# Access Compliance Report

## Public Rights-of-Way

Intersection ID: 2772	Main Street: BELL'S_MILL_DR	Cross Street: TARLAND_LN	Location: SW
ADA ID: 7E56E66C2EA1	Ramp Type: PerpDiag	Initial Pass/Fail: Fail	Overall Compliance: No
Severity Score: 21.25			
Codes/Mitigation Info/Possible Solution		Field Measurements/Component Compliance

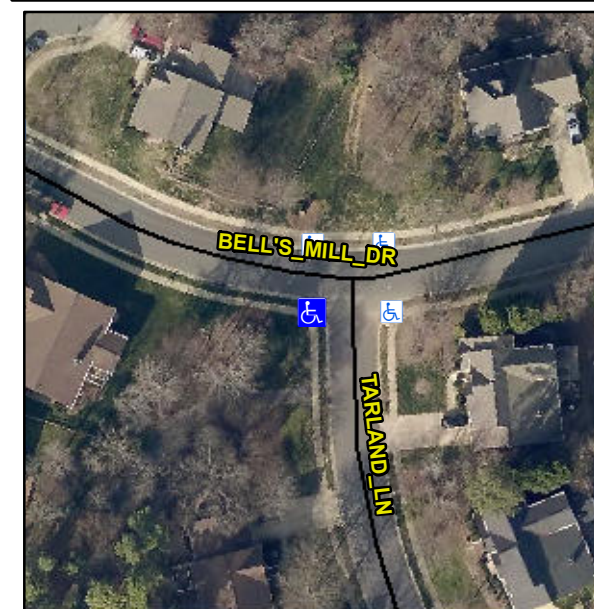
**R304.5.1, R304.5.3**

Compliance	Description	Data	Compliance	Description	Data
N/A	Ramp Length (in)	48.0	Yes	Ramp Slope (%)	7.6
No	Ramp Width (in)	36.0	No	Ramp XSlope (%)	6.8
N/A	Flare Type LT	N/A	N/A	Flare Type RT	N/A
N/A	Flare Slope LT (%)	N/A	N/A	Flare Slope RT (%)	N/A
N/A	Flare Traversable LT?	N/A	N/A	Flare Traversable RT?	N/A
N/A	Landing Length (in)	N/A	N/A	DWS Provided?	N/A
N/A	Landing Width (in)	N/A	N/A	DWS Contrast?	N/A
N/A	Landing Slope (%)	N/A	N/A	DWS Length (in)	N/A
N/A	Landing X Slope (%)	N/A	N/A	DWS Full Width?	N/A
N/A	Landing Curb? (Y/N)	N/A	N/A	DWS Offset (in)	N/A
N/A	Shared Landing?	N/A			
N/A	Gutter Ponding?	N/A	N/A	Gutter Slope (%)	N/A
N/A	Gutter Lip Ht (in)	N/A	N/A	Gutter X Slope (%)	N/A
N/A	Painted X Walk1?	No	N/A	Painted X Walk2?	No
	X Walk 1 Direction	To E		X Walk 2 Direction	To N
N/A	X Walk 1 Width (in)	N/A	N/A	X Walk 2 Width (in)	N/A
	X Walk 1 Slope (%)	4.2		X Walk 2 Slope (%)	1.2
	X Walk 1 X Slope (%)	2.8		X Walk 2 X Slope (%)	2.2

**Remove & Replace Curb Ramp With Two New Directional Ramps or Equivalent.**
